As-Built Baseline Monitoring Report – Riparian Buffer Mitigation

STRAWBERRY HILL MITIGATION PROJECT

NCDMS Project #100094 (Contract #7745) USACE Action ID: SAW-2019-00124 DWR Project #2019-0159

RE: DMS Comments on the Draft As-Built Baseline Monitoring Report

Figure 1: Site Location Map Figure 2: Current Conditions Plan View Map Figure 3: As-Built Planting Map Figure 4: As-Built Riparian Buffer Map Figure 5: Site Preparation and Other Activities Map Figure 6: ESC Plan Map

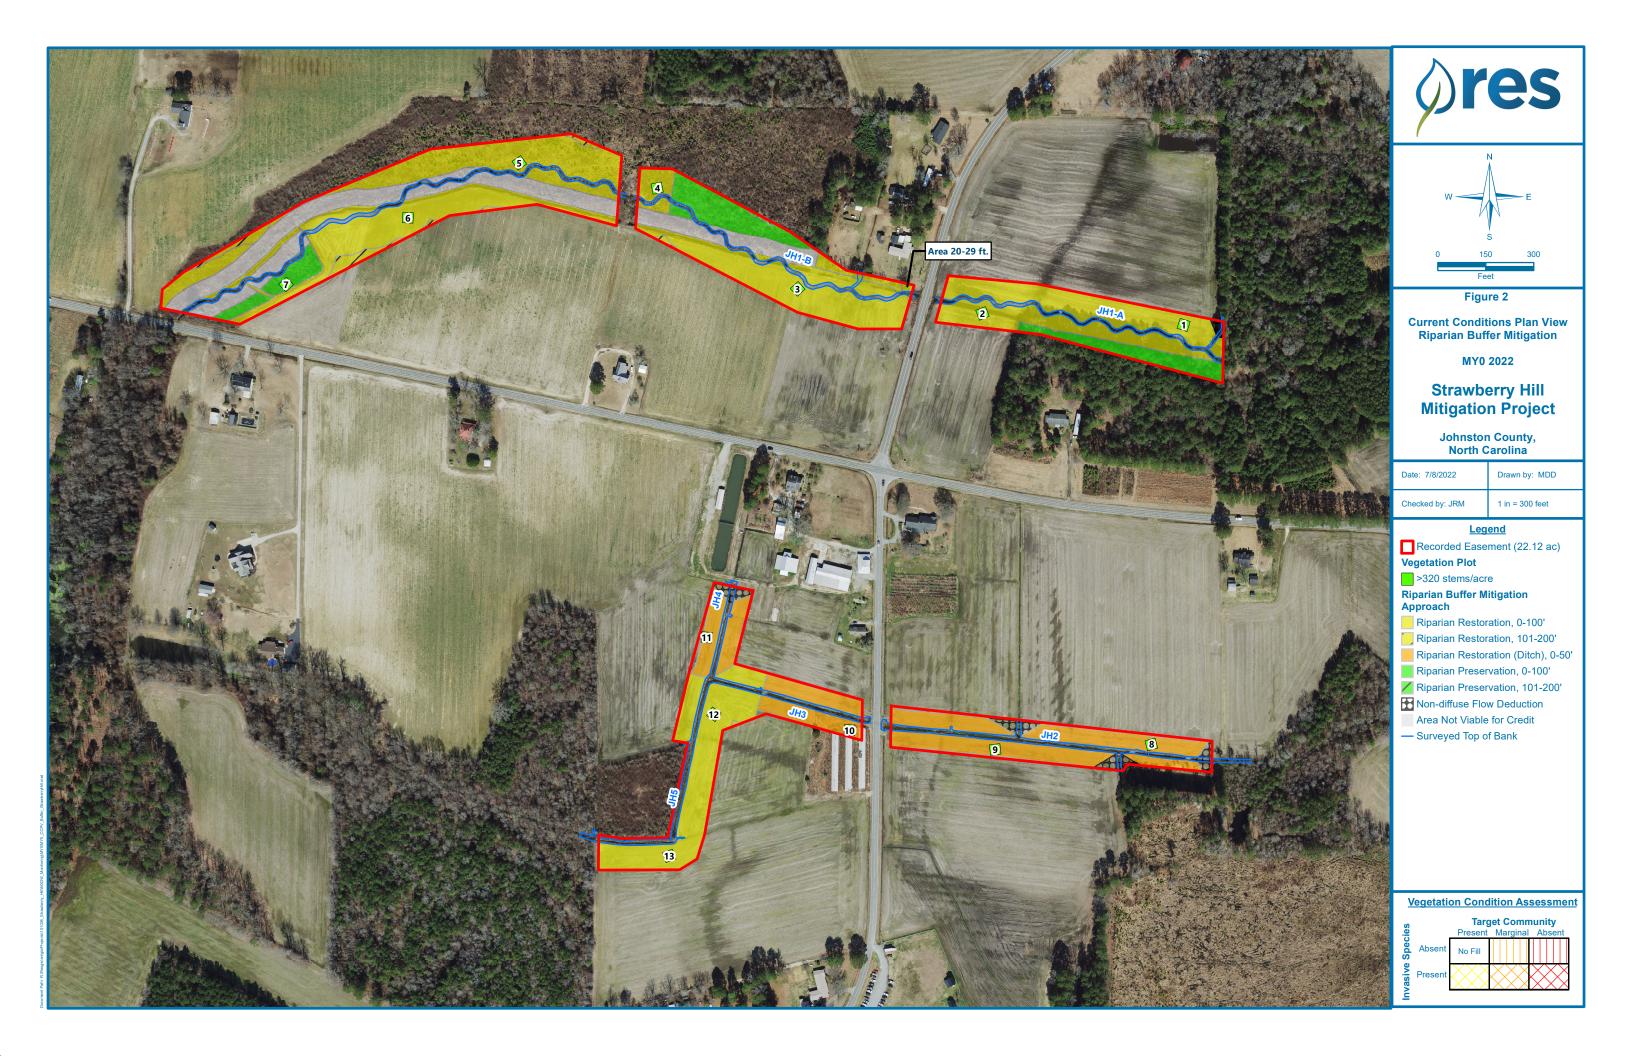
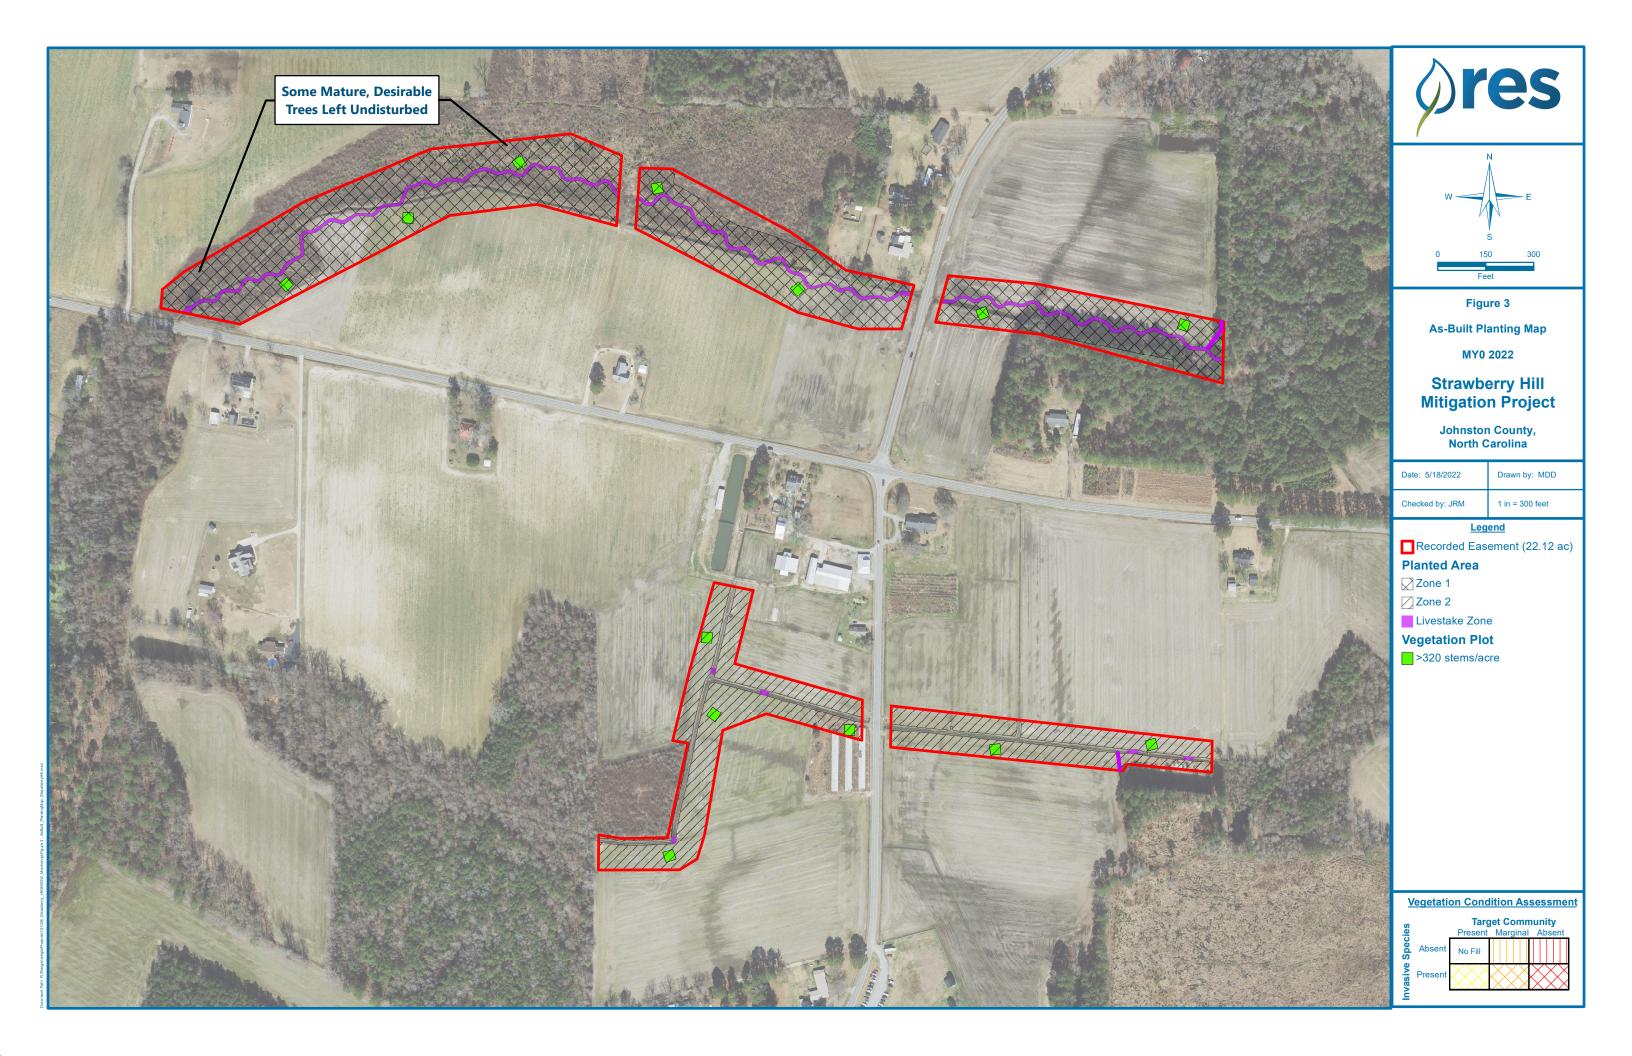
- 1. It is not possible to ensure the easement is accurate when compared to the CCPV in the stream asset baseline report, the CCPV does include the entire easement. The digital easement submitted does represent the DMS recorded easement. A requirement of the CCPV is to include the easement boundary, please revise the CCPV in the Stream Baseline Report to include the entire easement boundary. It is complete in the Buffer Baseline Report.

- Figure 2 has been divided into Figure 2a and 2b so that monitoring devices are legible on 2a and the entire conservation easement is visible on 2b.
- 2. The tables used are not the most updated templates (2020); this project may not have been contracted with these as requirements. The tables are missing the following information:

Sh	neet List Table		
Sheet Number	Sheet Title		
	Cover		
M1	MAINTENANCE COMPLETED		
M2	MAINTENANCE COMPLETED

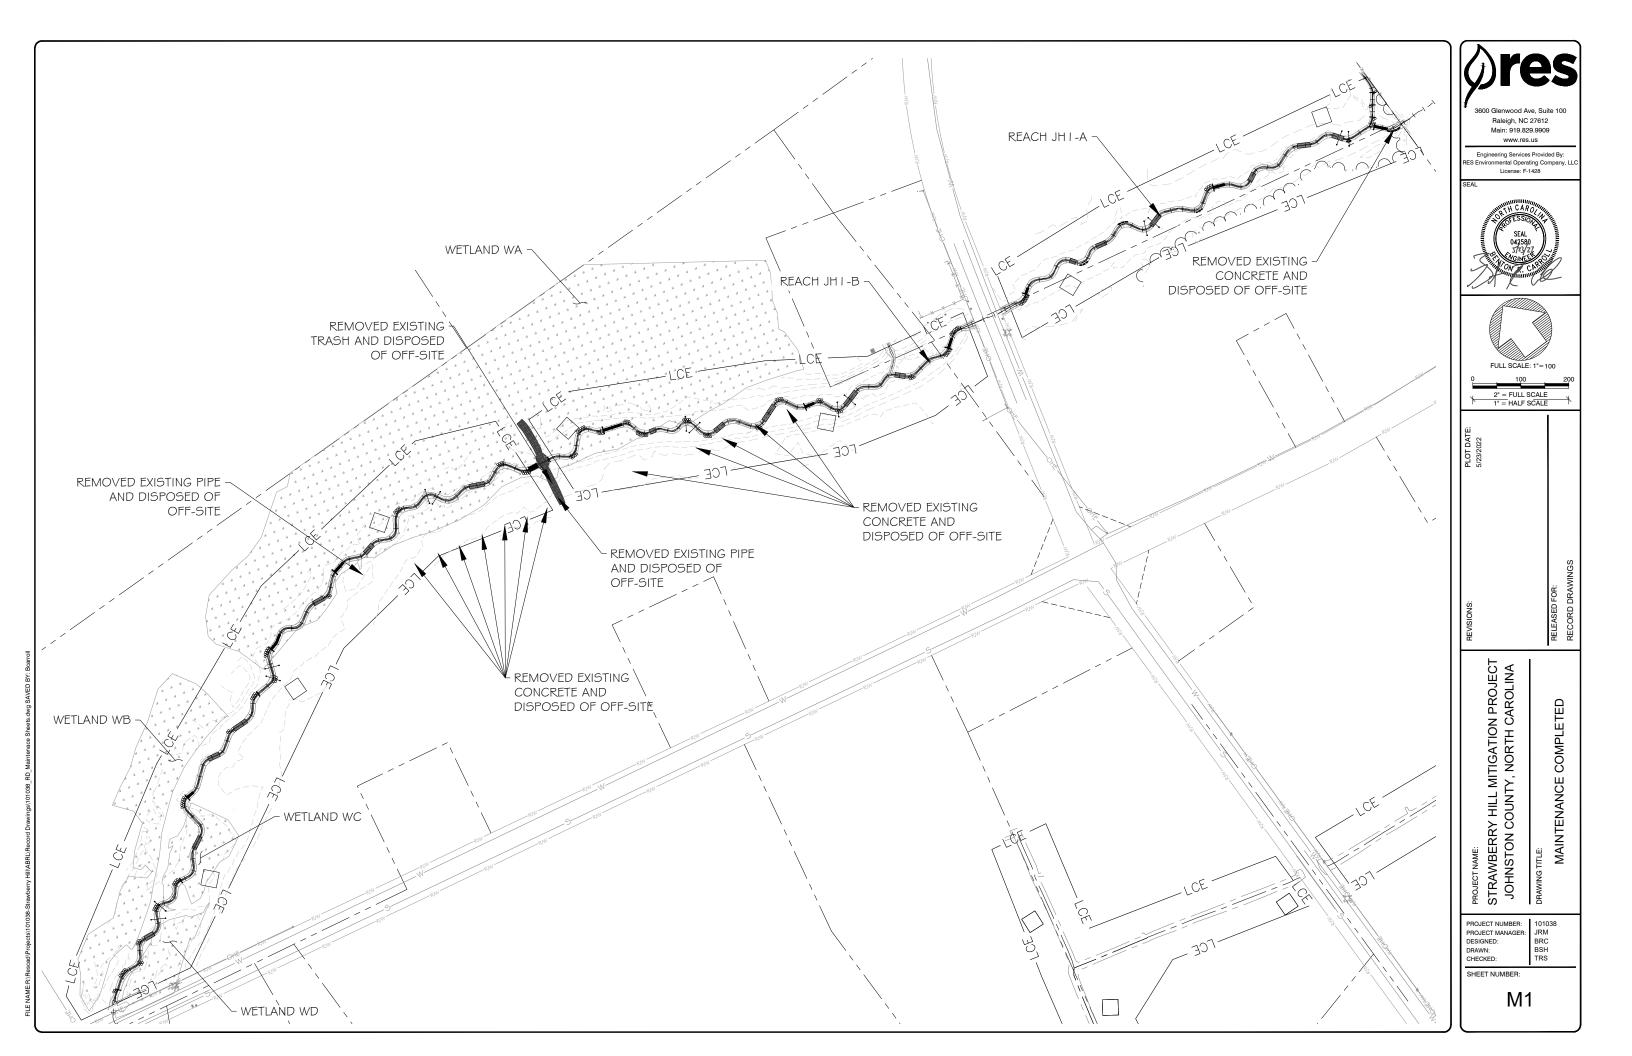
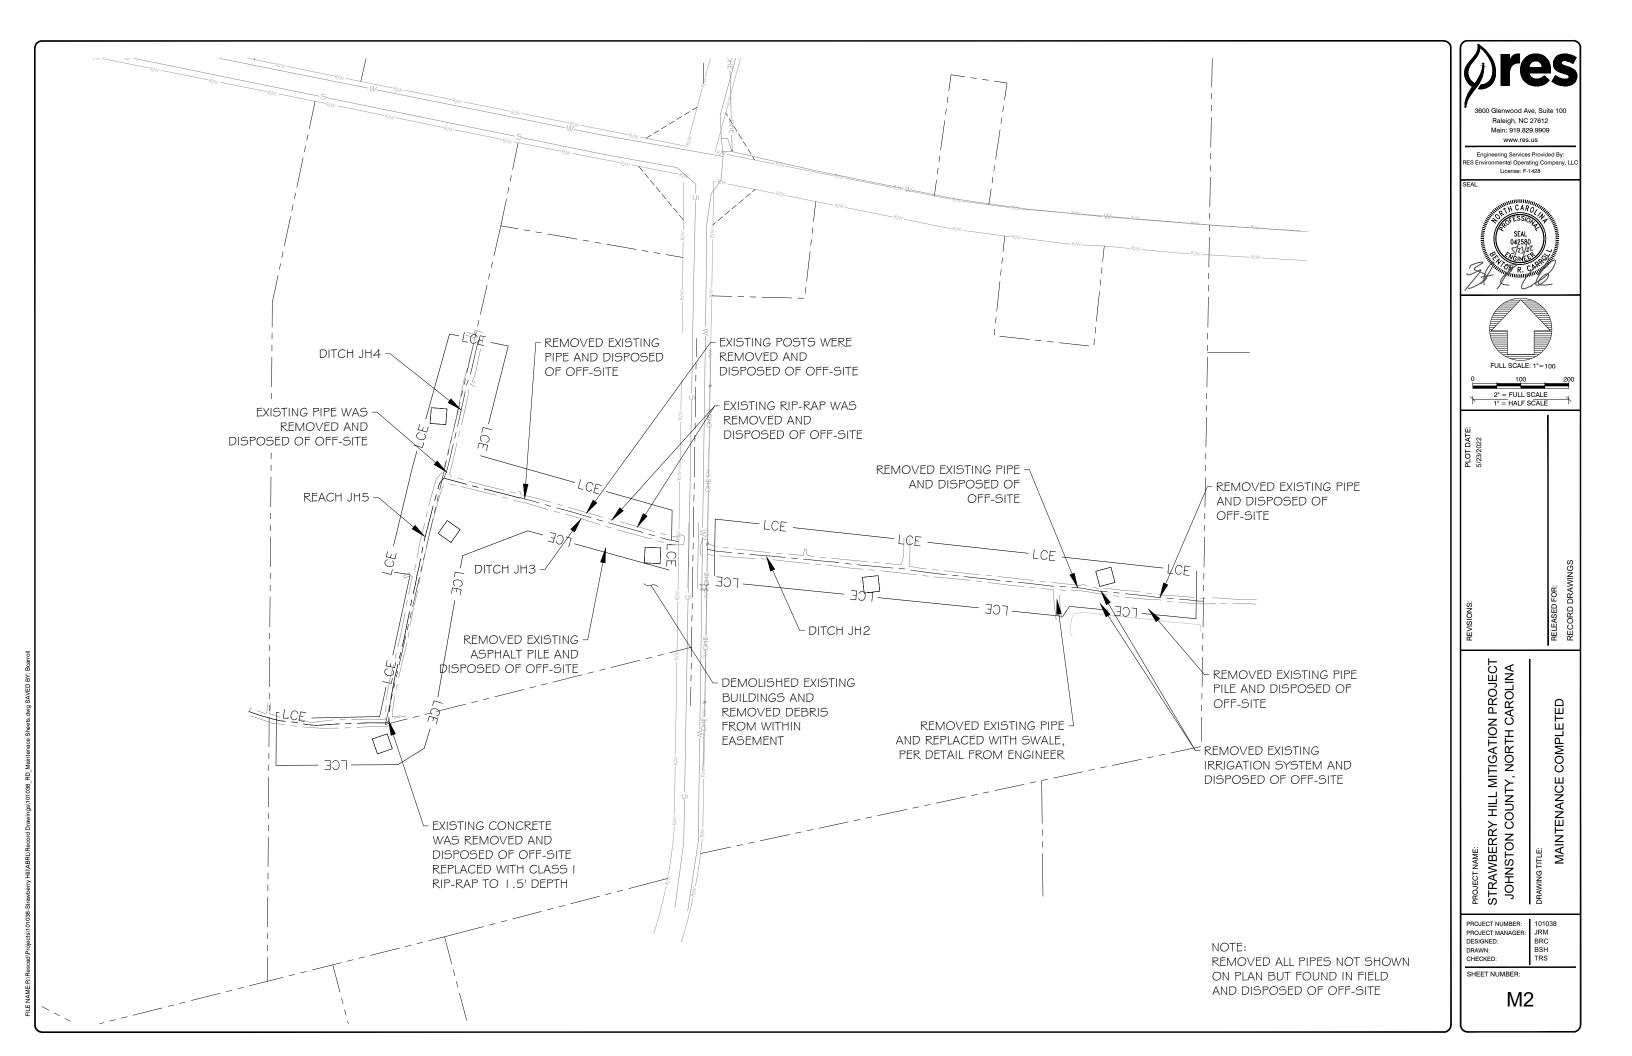
- Please add Limits of Disturbance to the Record Drawings.
 Limits of Disturbance (LOD) have been added to the Record Drawings.
- 4. Please consider updating the Sheet List Table on the Record Drawing Title Page in the buffer report only by removing the reference to sheets that are not included, or otherwise indicating that only sheets M1 & M2 are included. Also consider a reference to sheet EC2.

The Sheet List Table has been updated to only include references to sheets M1 and M2. A Cover Page has also been added for the ESC map with a reference to sheet EC2.
